Access Compliance Report Public Rights-of-Way (Curb Ramps)

Main Street: CHARDONNAY_DR		Cross Street: REGENT_PARK		Location:	SE
ADA ID: RPAT211103134145	Ramp Type:Type 1 - Perpendicular	Initial Pass/Fail: Fail	Overall Compliance: No	Severity Score:	16

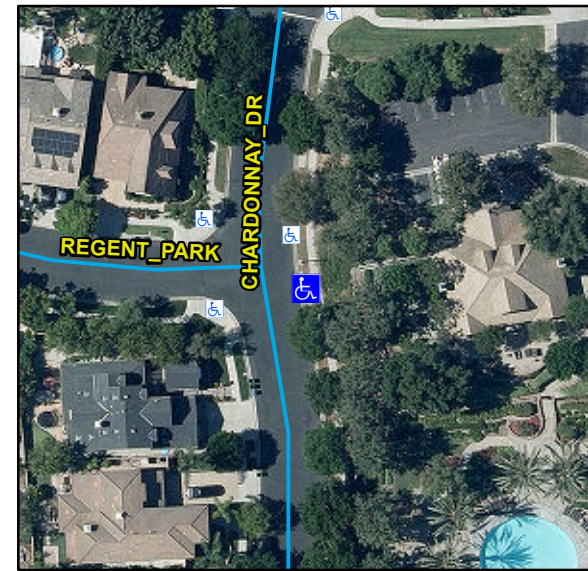
Compliance	Description	Data	Compliance	Description	Data
N/A	Ramp Length (in)	66	N/A	Flare Type LT	
Yes	Ramp Width (in)	48			N/A
No	Ramp Run Slope (%)	8.5	N/A	Flare Slope LT (%)	N/A
No	Ramp Cross Slope (%)	2.9	N/A	Flare Traversable LT	N/A
N/A	Landing Present	N/A	N/A	Flare Type RT	
N/A	Landing Length (in)	N/A			N/A
N/A	Landing Width (in)	N/A	N/A	Flare Slope RT (%)	N/A
N/A	Landing Run Slope (%)	N/A	N/A	Flare Traversable RT	N/A
N/A	Landing Cross Slope (%)	N/A	N/A	DWS Provided	N/A
N/A	Landing Movement Obstructed?	N/A	N/A	DWS Contrast	N/A
	Landing Movement Type	N/A	N/A	DWS Length (in)	N/A
N/A	Landing Shared	N/A	N/A	DWS Full Width	N/A
N/A	Clear Space	N/A	N/A	DWS Offset Left (in)	N/A
N/A	Clear Space To Crosswalk (in)	N/A	N/A	DWS Offset Right (in)	N/A
N/A	Marked Crosswalk 1	No	N/A	Marked Crosswalk 2	N/A
	Crossing 1 Direction	W		Crossing 2 Direction	N/A
	Marked Crosswalk 1 Width (in)	N/A		Marked Crosswalk 2 Width (in)	N/A

N/A	Ramp Inside Crosswalk 1	N/A	Yes	Ramp Inside Crosswalk 2	N/A
	Crossing 1 Slope (%)	1.9		Crossing 2 Slope (%)	N/A
	Crossing 1 Cross Slope (%)	1.5		Crossing 2 Cross Slope (%)	N/A
N/A	Gutter Ponding	N/A	No	Curb Slope	10
Yes	Gutter Lip Height (in)	0		Road Run Slope (%)	N/A
N/A	Gutter Run Slope (%)	N/A		Road Cross Slope (%)	N/A
N/A	Gutter Cross Slope (%)	N/A			
Yes	Overall Surface Condition: Acceptable		No	Perp Joint Present	No
	Cross Gutter Present?	No		Spandrel Present?	No
	Replace Cross Gutter?	N/A		Replace Spandrel?	N/A

Remove & Replace Entire Ramp.

R304.2.2, R204.3, R304.5.3, STD 1115
